STAFF REPORT
CITY OF BEVERLY HILLS

**For the Design Review Commission
Meeting of June 3, 2010**

SUBJECT: A request for an R-1 Design Review Permit to allow the construction of a new two-story single-family residence, located in the Central Area of the City, south of Santa Monica Boulevard at **126 North Maple Drive. (PL 101 0459).**

Continued from the meeting of May 6, 2010

Proposed - Front Elevation (6/3/10)

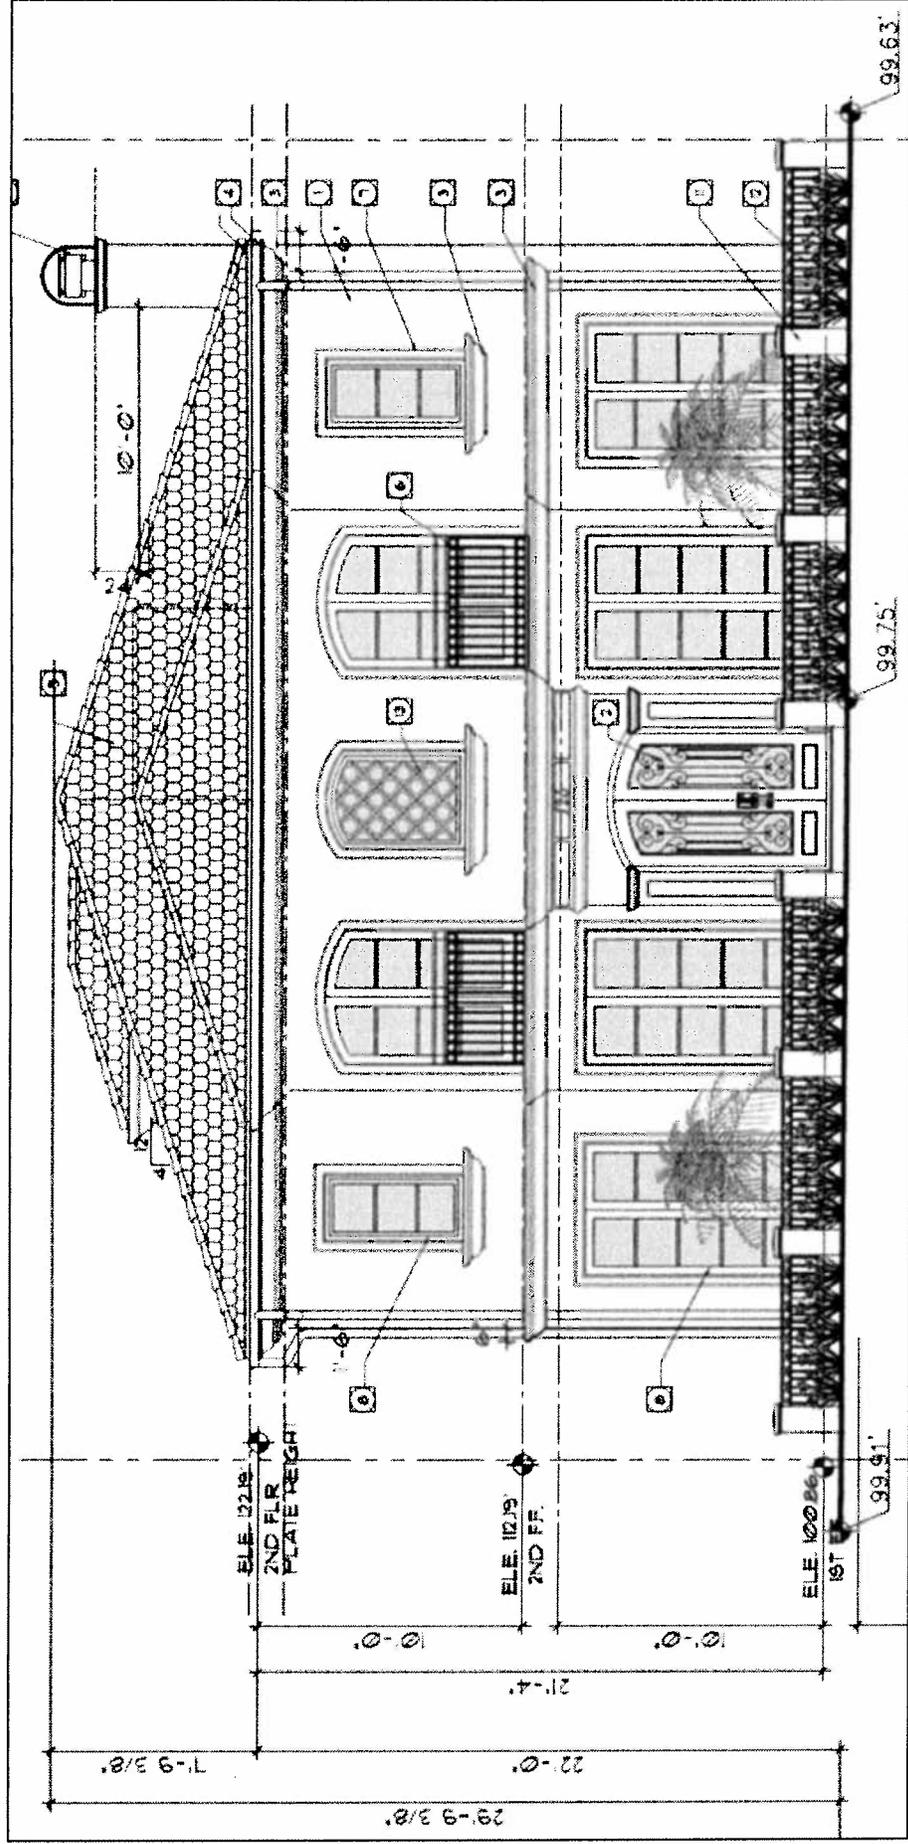
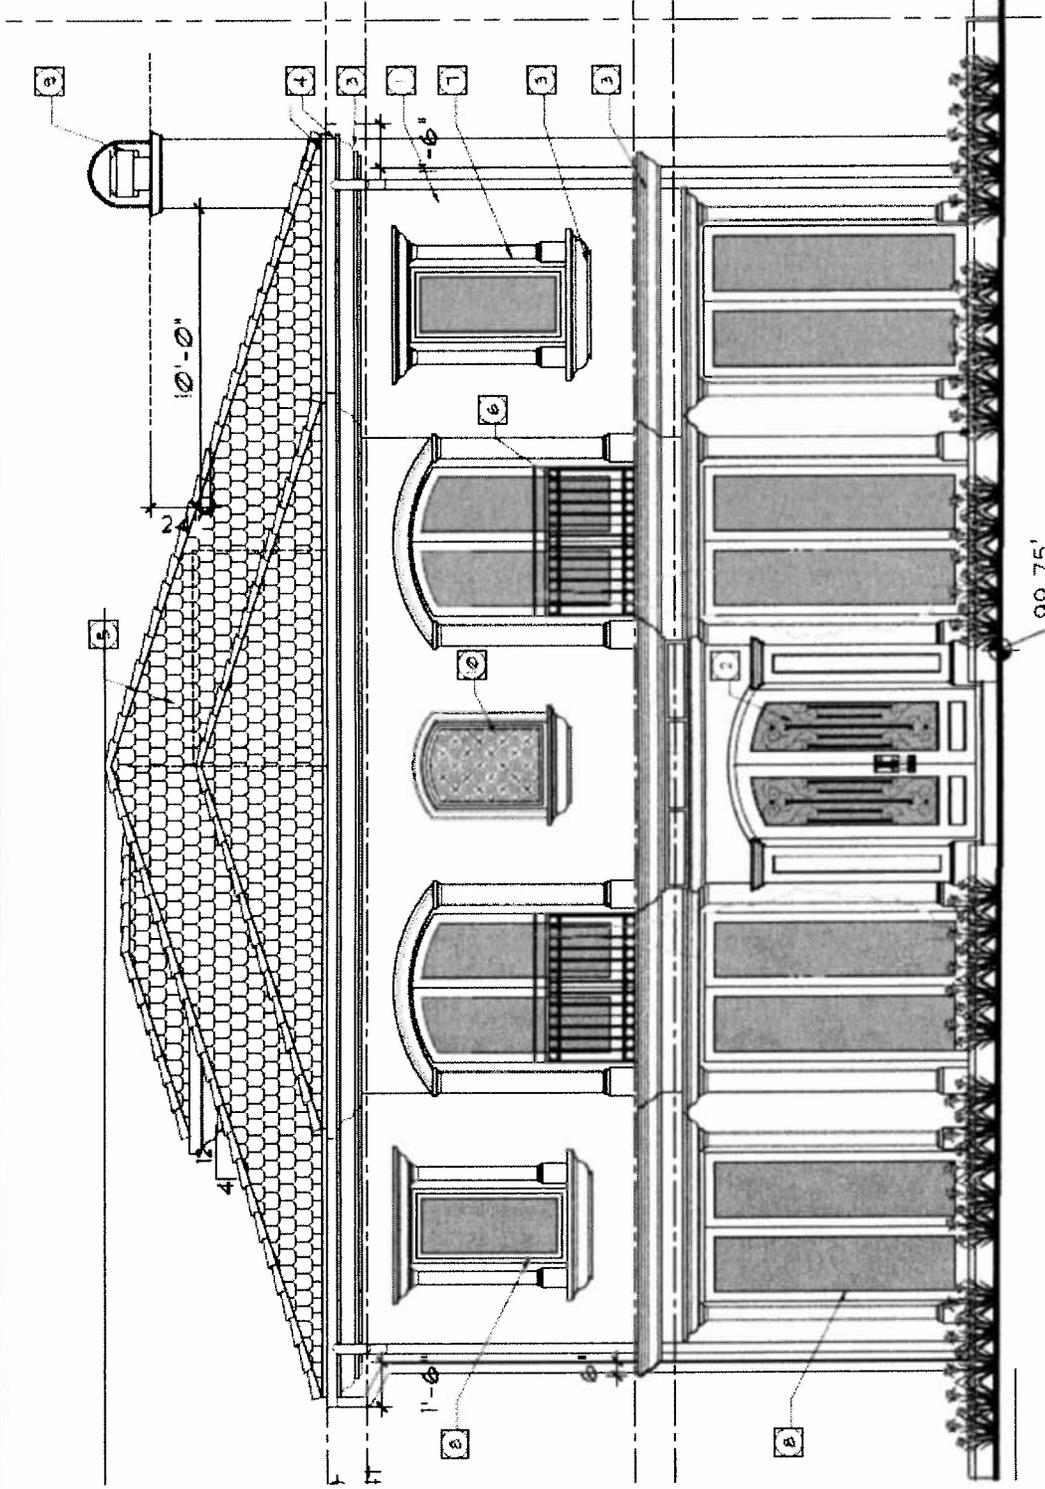
Commission Comment	Proposed Modification
1. The windows at the stairwell and along the street-side elevation should be restudied, and possibly made taller.	1. The applicant added a small, round window at the top of the stairwell. Additionally, the height of the windows along the street-side elevation was increased in order to provide for wrought iron railings.

2. The exterior stairs along the street-side elevation should be eliminated.	2. The exterior stairs have been eliminated.
3. The street side elevation, including the trims and windows, needs more modulation/design to prevent the appearance of one flat facade.	3. Additional pre-cast molding has been added around the openings along the street-side elevation, second-floor windows have been made taller with wrought iron railings, and two, small peaks have been added to the roofline.

8. The proposed design is very boxy and does not take advantage of its corner location. The structure should be redesigned to appear less massive, and the corner location needs to be incorporated into the design and orientation of the project.	8. Other than the modifications outlined above, no substantial design changes were made to address the boxy appearance of the project or its corner location.
Additionally, it should be noted that the horizontal mullions on the front of the project have been removed from the renderings and elevations. The window and door schedules still show horizontal mullions, and staff has recommended a condition to restore the mullions on the front façade and add mullions to the street-side façade.

1. Horizontal mullions shall be added to the windows and doors along the front and street-side elevations.
2. Any approval by the Commission is for design only; the project is subject to all applicable City zoning regulations.
3. Final plans shall include spec sheets for windows and call-outs on a colored elevation for each material proposed for verification in the field during construction.
4. Any future modifications to this approval shall be presented to staff for a determination as to whether the change may be approved by staff (minor) or to the Commission for review.
